DEVIATION REQUEST AND DECISION FORM

Project Name : Homestead North Phase 1 SP-20-008
Schedule No.(s) : 5228000030
Legal Description : THAT PT SE4 SEC 28-12-65 & PT N2N2 SEC 33-12-65 LY ELY OF ELY R/W LN OF VALLMER RD DESC AS FOLS:
COM AT NE COR SE4 SEC 28, TH S 89<0831W ON N LN 128.37 FT, S 20<4157E 261.04 FT, S 36<3659W 139.21
FT, S 17<4007W 65.20 FT, S 17<1441E 84.16 FT, S 17<1743E 155.83 FT, S 09<1039W 166.63 FT, S 08<2217E

Deviation Request for Intersection Spacing Along a Minor Arterial

Deviation Exhibit No. 3

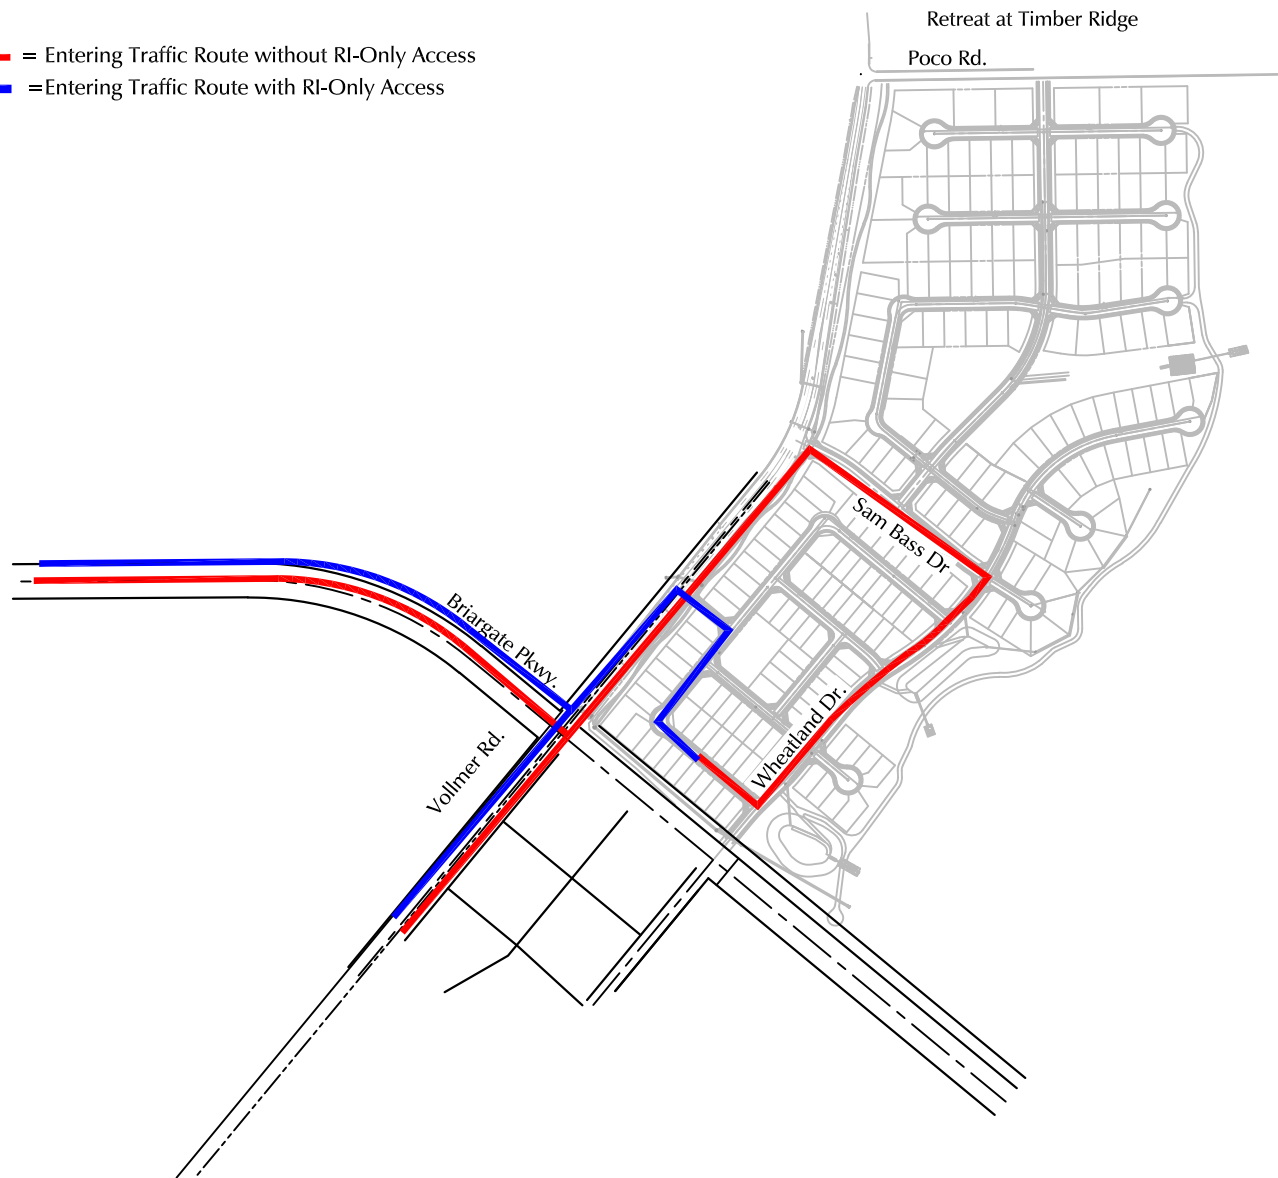
Exhibit 1 shows the location of the Homestead North development and Exhibit 2 shows the location of the proposed right-in only access that will require a deviation to the *ECM* criteria. The applicant is requesting this access to reduce the out-of-direction travel to the southern portion of the development for motorists arriving from the south, west, or southwest. As there is not sufficient intersection spacing for an eastbound left turn from Briargate Parkway (Stapleton) at Wheatland Drive, this access would be a good alternative to improve to accessibility to the southern portion of the site. Future residents in the southern portion of the site would not need to travel about one-quarter mile up Vollmer Road, turn right at Sam Bass Drive, and backtrack through the north portion of the subdivision to reach the homes in the southern portion. Exhibit 3 shows the traffic routes with and without the proposed right-in only access.

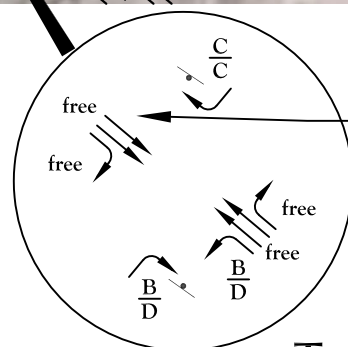
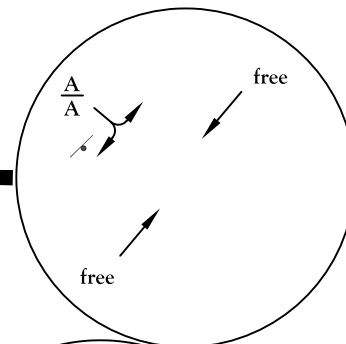
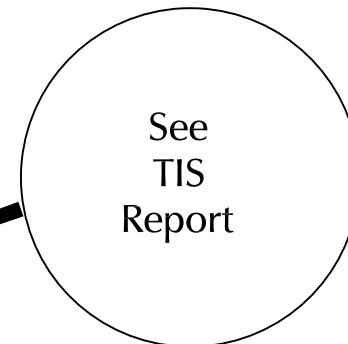
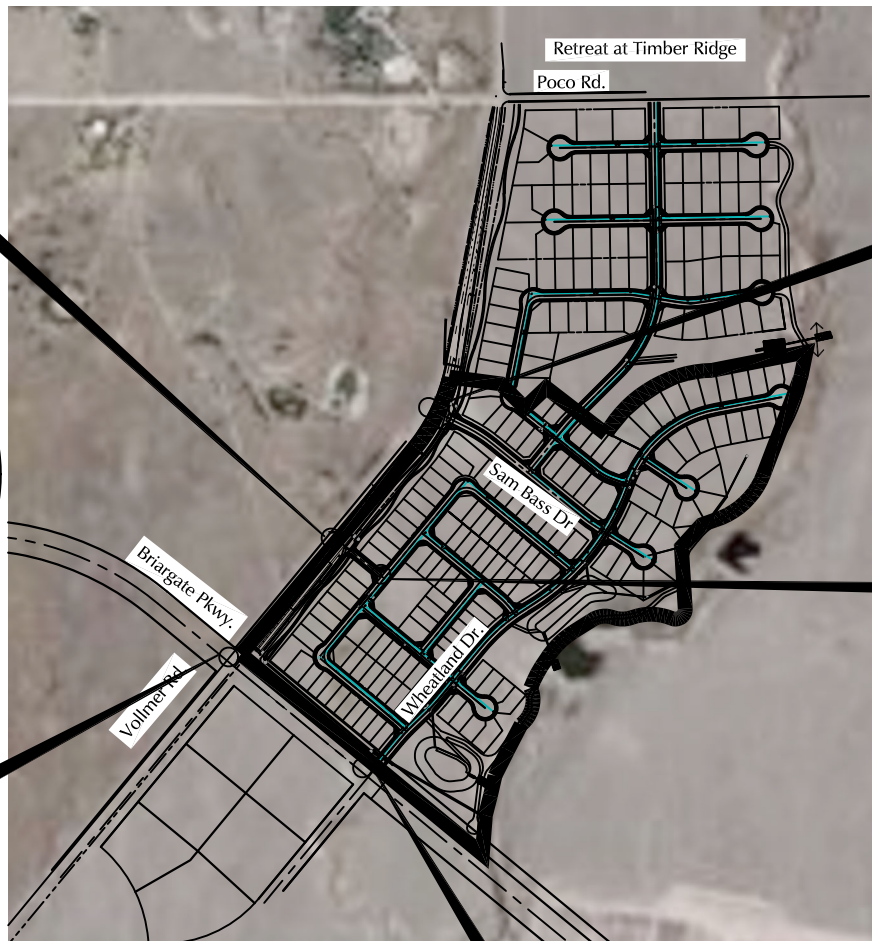
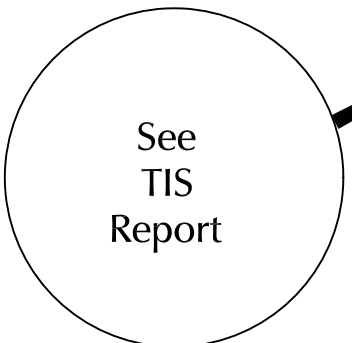
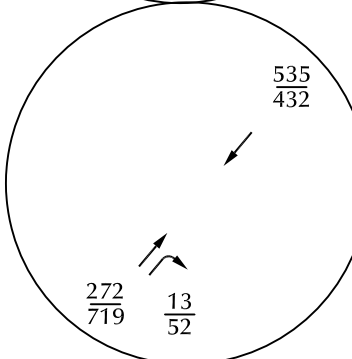
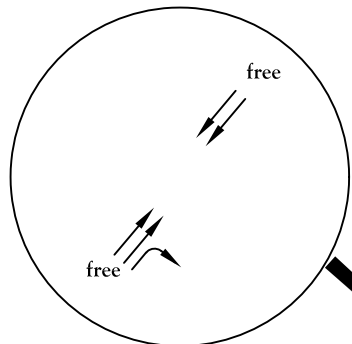
Exhibit 4 shows a sight-distance analysis for the proposed right-in only intersection of Vollmer Road/Jane Kirkham Drive and the first internal intersection to the east (Jane Kirkham Drive/Texas Jack Drive). As shown in this exhibit, these intersections meet the criteria for both stopping sight distance and intersection sight distance.

Deviation Exhibit No. 6
Jane Kirkham Drive Typical Section*
 Homestead North Phase 1 (LSC #204380)

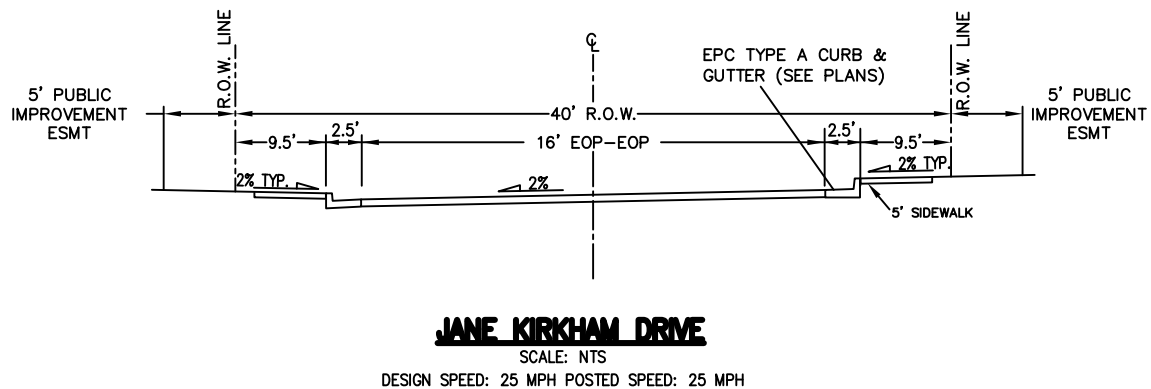
Exhibit 6 shows the proposed cross-section for Jane Kirkham Drive.
